Oakland City Planning Commission
Design Review Committee

STAFF REPORT

Case File Number PLN20141

The purpose of this report is to provide information about the draft site-specific design guidelines (Design Guidelines) for re-development at 5212 Broadway, the former California College of the Arts (CCA) Campus. The Design Guidelines are intended to provide supplemental information to decision makers that support the required findings and to provide guidance for design review as part of the PUD.

Figure 2.10: New building high visibility edges and adjacencies

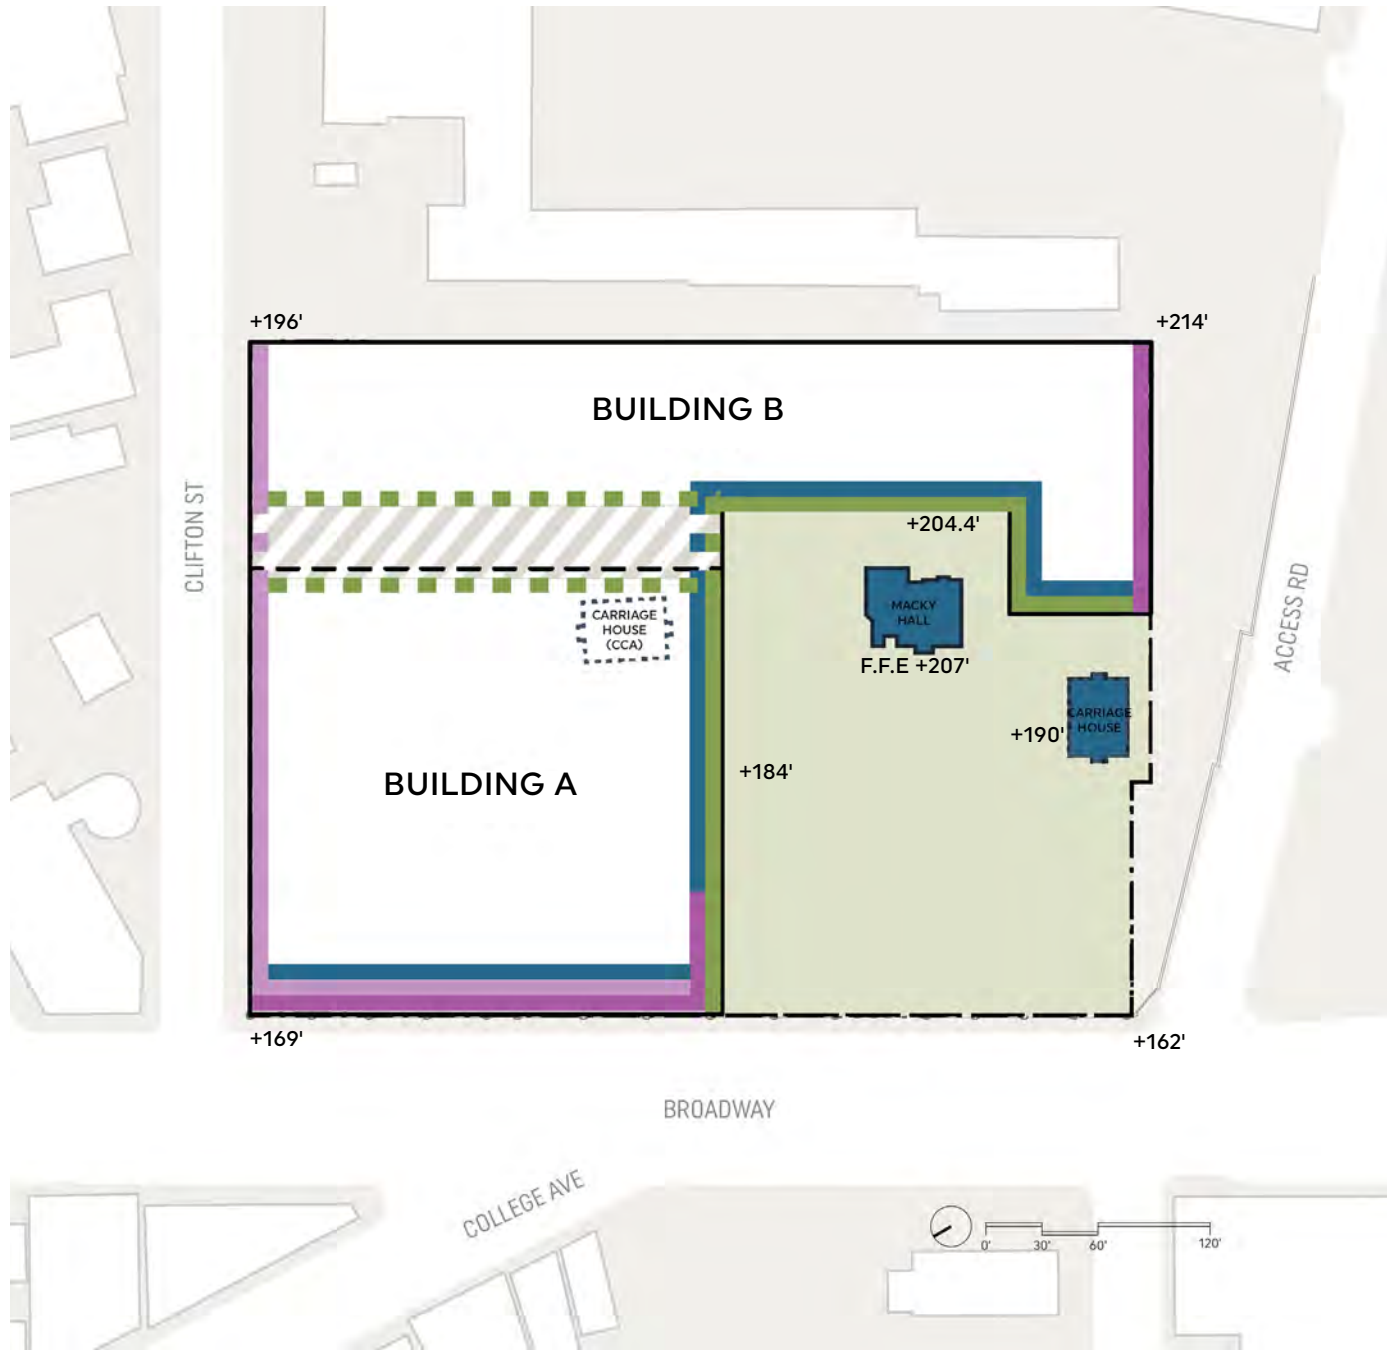
This increased height could occur on the highly visible edges (purple area) on Figure 2.10. Are these the portions of the site where additional height is desired?

Figure 2.12: Setback zones surrounding Macky Hall and Carriage House

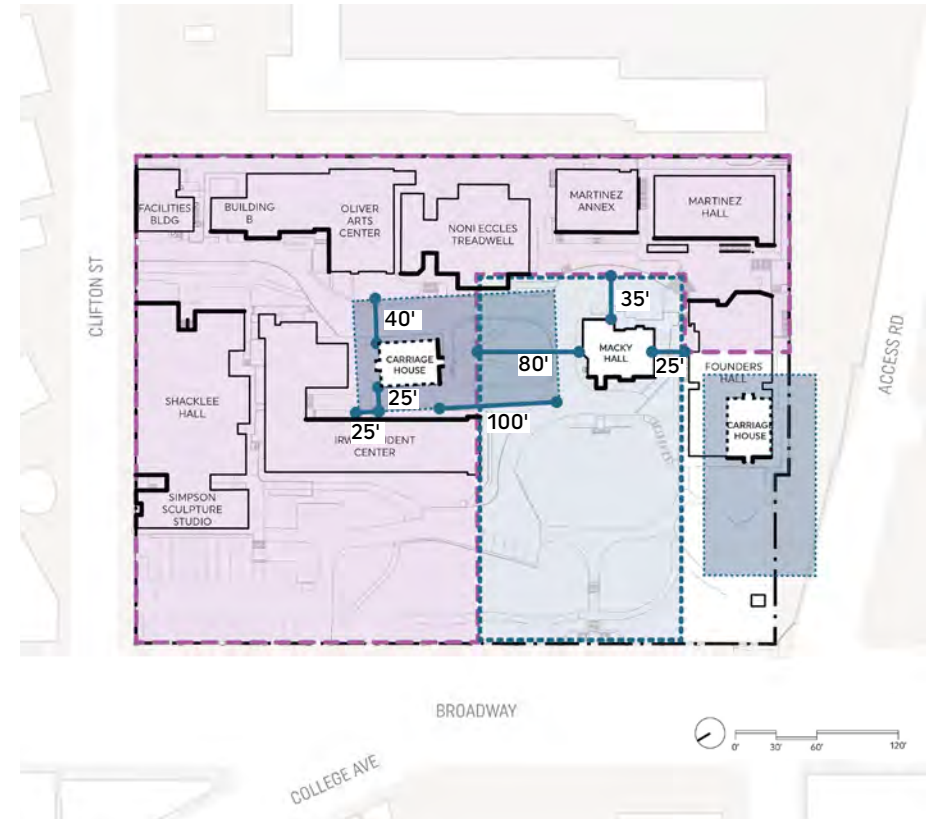
The Macky Hall Height Reduction Zone only addresses a small portion of Building B. Three 60- foot changes in plane will be insufficient to alter perceived massing given the allowed height outside the Height Reduction Zone and building footprint. The Macky Hall 35' setback (GL2.5.8) is also insufficient for this purpose given the height allowed.
